ALERT SERVICE BULLETIN

SUBJECT: REVISION "A" TO ALERT SERVICE BULLETIN 206-02-99: (MAIN ROTOR BLADES 206-010-200-ALL INSPECTION AND REWORK OF)

NO. 206-02-99

SUBJECT: MAIN ROTOR BLADES 206-010-200-ALL
INSPECTION AND REWORK OF

Figure 1. Area to inspect

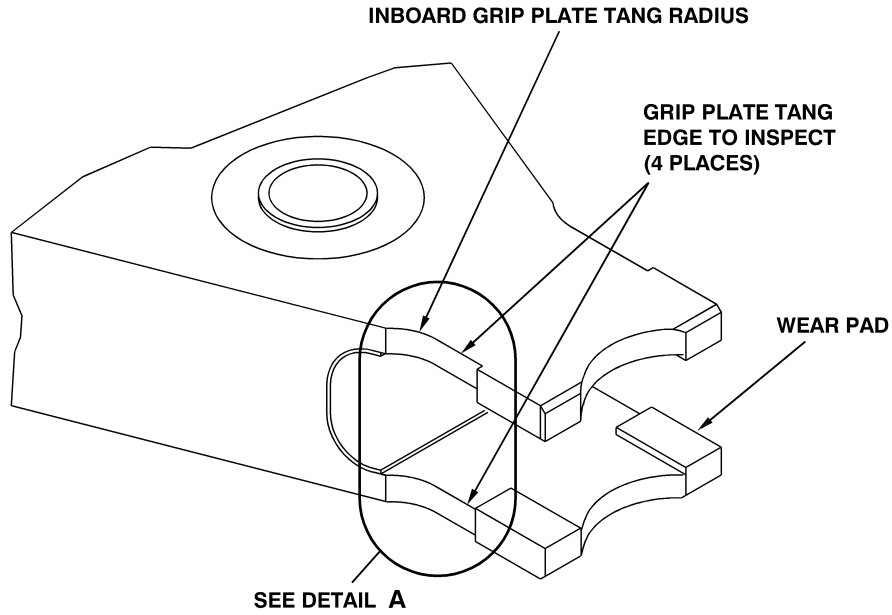
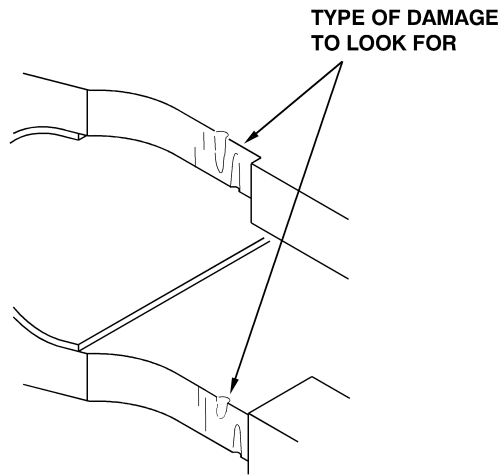
Bell Helicopter found that some main rotor blades may have tool marks made during manufacturing on the edges of the grip plate tangs. These tool marks if not removed may lead in cracking of the grip plate tang.

- A**
1. Inspect the blade grip plate tangs leading and trailing edges between the wear pads and the inboard radius for presence of tool marks (Figure 1). The surface should be flat, with no waves or notches (Figure 1, DETAIL A).
 2. If a damage or an irregularity on the surface as shown on the Figure 1 is found, do PART II of this Alert Service Bulletin.
 3. If no damage or irregularity on the surface as shown on the Figure 1 is found, the blade is serviceable.
 4. Using a vibrating stylus, mark ASB 206-02-99 on the blade Modification Plate to indicate that this Alert Service Bulletin has been accomplished.
 5. Make an entry in the Helicopter and the Component Historical Records to show that this Alert Service Bulletin is completed.

3. Measure the depth of the damage.
4. If the depth of the damage exceed 0.050 inch (1.27 mm) remove the blade from service.
5. Send the defective blade to Bell Helicopter Customer Property Return with a Malfunction Report attached with the ASB number in reference.
6. If the depth of the damage is at 0.050 inch (1.27 mm) or less do PART III of this Alert Service Bulletin.

1. Using a single cut general purpose half round file No 2 or 3 (smooth cut) blend smooth the damages in a ratio of 10 to 1. As an example, if the damage is 0.040 inch (1.5424 mm) deep, blend 0.400 inch (15.24 mm) on each side of the damage. The maximum depth after rework is 0.050 inch (1.27 mm).
2. After blending with the file, polish the surface with 180-220 grit Aluminum Oxide Fabric Cloth to obtain a finish of 63 RMS.
